Attachment 4. NRC Correspondence

Subject: Moab Uranium Mill Tailings Remedial Action (UMTRA) Project Remedial Action Plan

SUBJECT: REVIEW OF REQUESTED MODIFICATION TO THE REMEDIAL ACTION PLAN
FOR THE MOAB URANIUM MILL TAILINGS REMEDIAL ACTION PROJECT

The purpose of this letter is to request Nuclear Regulatory Commission (NRC) concurrence on a specification and design drawing change to the Moab UMTRA Project Remedial Action Plan. The U.S. Department of Energy (DOE) is proposing the following changes:

Figure 1. Location of portion of disposal cell with insufficient cover.

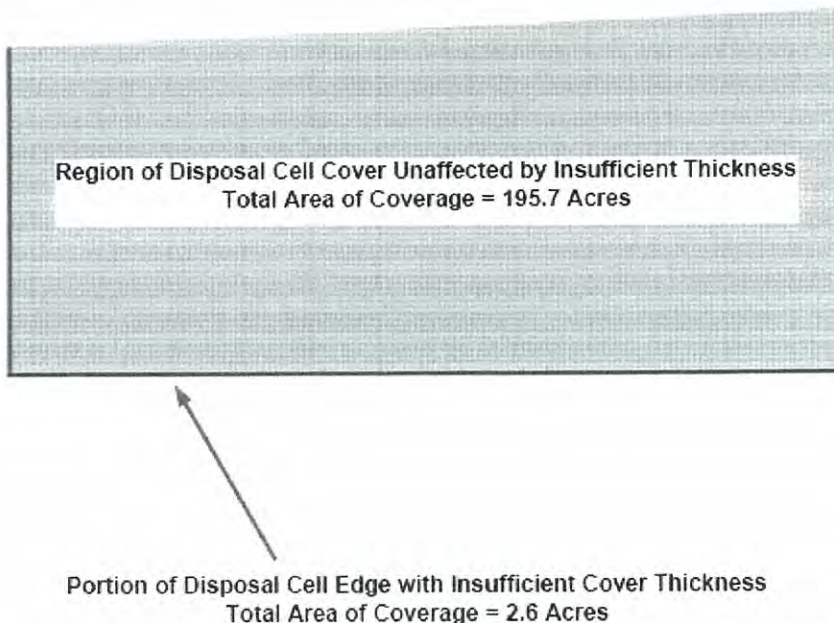
The Department of Energy (DOE) recently identified a discrepancy in the designed thickness of a portion of the cover as presented in the final Remedial Action Plan (RAP). The plan received conditional concurrence in July 2008. The discrepancy pertains to the thickness of the planned disposal cover over a 14-foot-wide section of the residual radioactive material (RRM) located on the eastern, western, and southern edges of the cover (See Figure 1).

Figure 2. Radon barrier at edge of cell as per E-02-C-501.

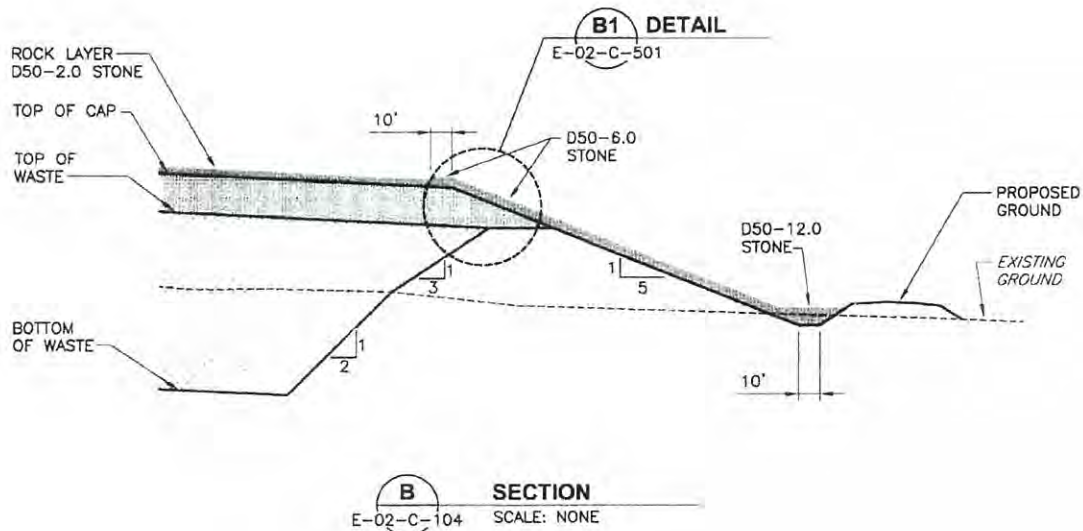
As designed, the sloping cell cover creates a section that is less than the intended full cover thickness as shown on drawing E-02-C-501 section B (see Figure 2). Approximately 2,400 linear feet of RRM has been placed to the design elevation which when the cover materials are placed will have approximately 6 feet of total cover thickness rather than the intended 8.5 feet. In this area the frost protection layer would be reduced.

To evaluate the impact on radon emanation of the cell cover having a reduced thickness, the DOE has performed an evaluation of the radon emanation assuming a reduced frost protection layer. The evaluation showed that though the radon flux exceed the Nuclear Regulatory Commission (NRC) radon limit of 20 pCi/m²/sec in the area of concern, the overall average flux from the eventual completed cell did not change and is under the NRC limit.

Figure 3. Profile showing reduced RRM placement and additional interim cover.

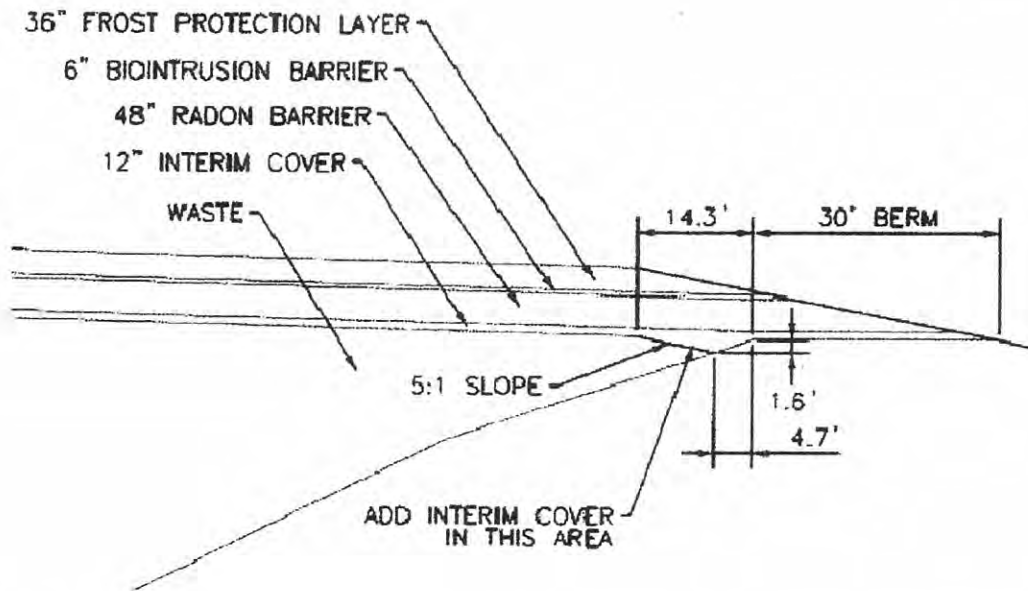
As a result, the DOE is requesting concurrence to leave the RRM already placed to the design elevation. As a best management practice, the DOE may reduce the thickness of RRM placed along the yet-to-be-filled portion of the cell, which would allow an associated increase in the thickness of the final cover to the design of 8.5 feet as shown in Figure 3. Along with this request, we would like to leave the existing drawing set in the RAP as submitted. Appropriate adjustment to the cell as-built drawings will be made and submitted with the completion report.

Figure 1 - Current approved design for Moab (from ML082180244)

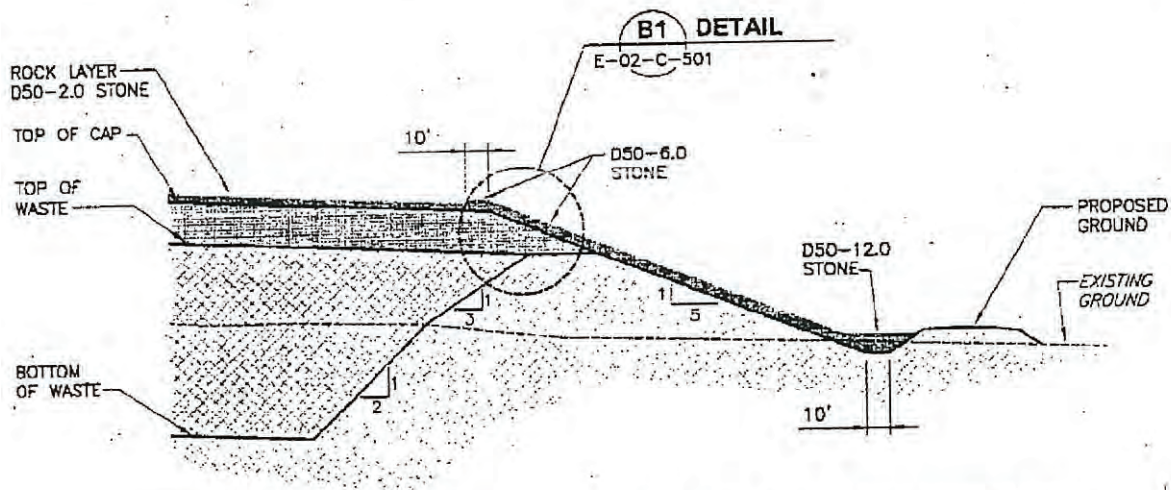
The approved configuration of the cover system is shown in Figure 1 above. Based on this configuration, the cover thickness over the RRM near the crest of the sideslope is approximately

6 feet (ft) instead of the intended 8.5 ft. In this area, the frost protection layer is less than the intended thickness.

Figure 2 – Proposed change to perimeter detail in yet to be filled areas (from ML101550357)

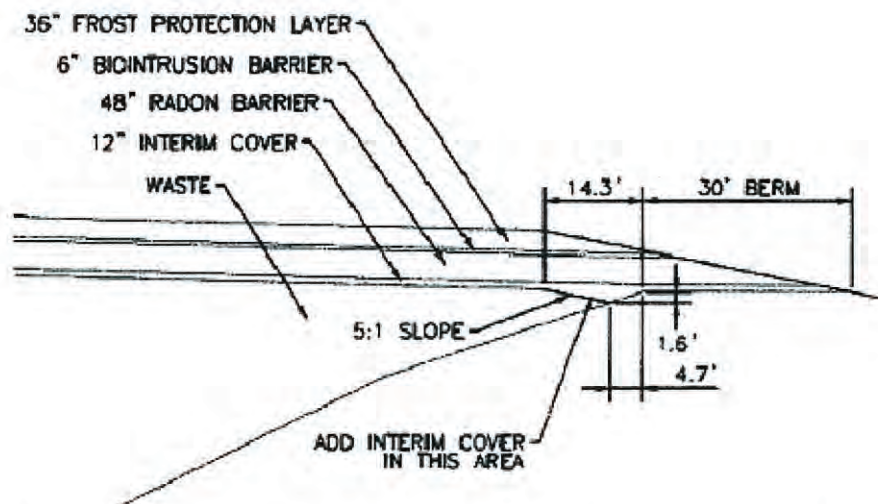
As a best management practice, DOE has developed a revised detail for RRM placement in the yet to be filled portions of the cell. In this revised detail, shown in Figure 2 below, the thickness of RRM would be reduced and replaced with additional interim cover to maintain the desired cover thickness of 8.5 ft. The final slopes and design elevations would remain unchanged.

The staff reviewed the geotechnical engineering aspects of the proposed change; specifically, the staff considered the changes in the design and their effect on the stability of the slope. The currently approved design calls for a maximum sideslope of 5 horizontal to 1 vertical (5H:1V) for the cover system. In the 2008 technical evaluation report (NRC, 2008, ML082060216), the staff determined that the design complied with the applicable requirements in 40 CFR 192. As DOE has not proposed any changes to the maximum sideslope and the cross section remains similar to the approved design, the previous conclusions remain valid and the staff considers the proposed change acceptable from a geotechnical engineering standpoint.

The staff also reviewed the erosion protection aspects of the proposed change. The staff focused its review on the maximum slope angle, maximum slope length, and upstream catchment area which may be different from the originally approved design. The staff notes that the maximum slope remains 5H:1V. Additionally, the grading plan remains unchanged so there are no changes to the maximum slope length or upstream catchment area. In the 2008 technical evaluation report (NRC, 2008, ML082060216), the staff determined that the design complied with the applicable requirements in 40 CFR 192. As the proposed changes do not alter the maximum slope angle, maximum slope length, or upstream catchment area, the previous conclusions remain valid and the staff considers the proposed change acceptable from an erosion protection standpoint.

Based on its review, the staff has reviewed the proposed change to RRM placement in yet to be filled portions of the cell and considers it acceptable. DOE may leave the existing drawing set in the RAP as submitted. DOE will ensure that appropriate adjustments to the cell as-built drawings are made and submitted with the completion report.

Figure 1. Detail from Drawing E-02-C-501-E showing location of riprap placement on cover edge

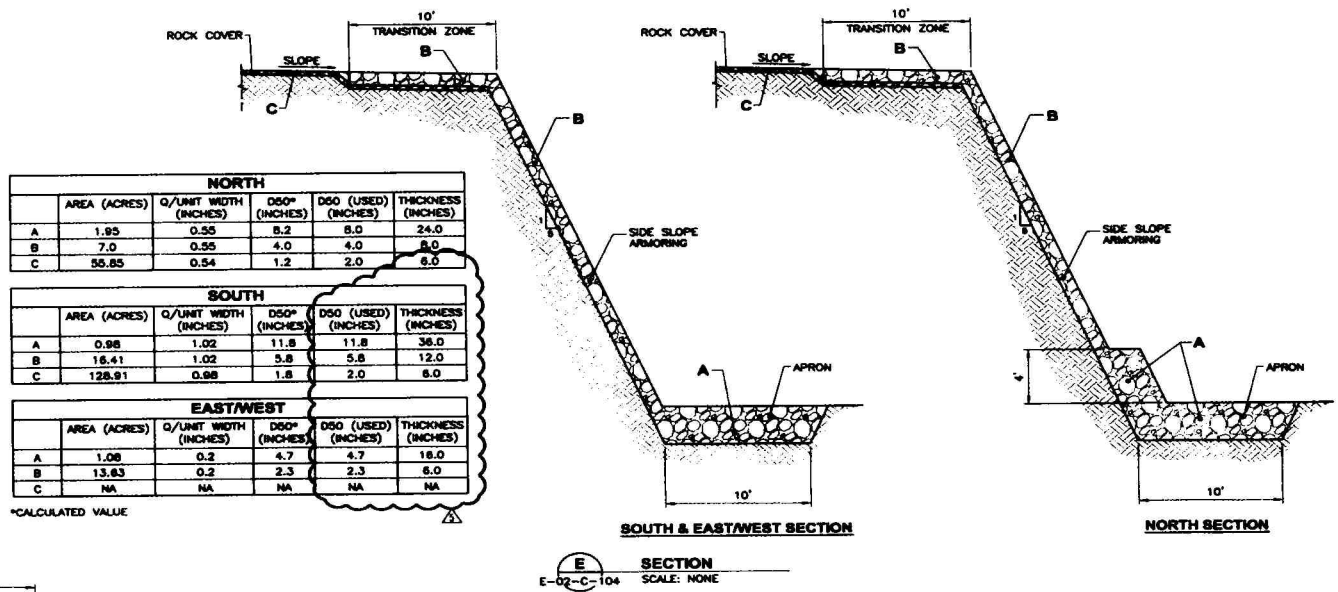
- 1) Drawing E-02-C-501 (proposed changes in the clouded area in Figure 1). The current approved drawing reflects a “calculated” value and a “used value” for the D50 of the rock size. The used values were established by taking the calculated value and in every case but one, rounding up to the nearest standard screen size. The proposed revised drawing below proposes to use the “calculated” as actual for the D50 12-, 6-, and 4-inch rock sizes.

- 2) During a conference call on May 4, 2011, between the NRC and DOE, we discussed the difficulty of sampling and testing riprap gradations. It was suggested that this project should research previous UMTRA projects to see what type of testing and specifications have been used in the past. DOE has reviewed and examined the sampling and testing methods used on previous UMTRA projects located in Green River, UT, and Grand Junction, CO. While reviewing previous UMTRA project specifications, we found that the target gradation bands on past projects are significantly larger than the bands that have been specified on the Moab UMTRA Project. In our letter dated September 15, 2010, we proposed a similar specification change to the aggregate utilized on the final cover (Area C) of the disposal cell, which NRC is currently reviewing. This request is in regard to the side slope riprap (Area B) and apron riprap (Area A) on the same disposal cell (See Figure 1).
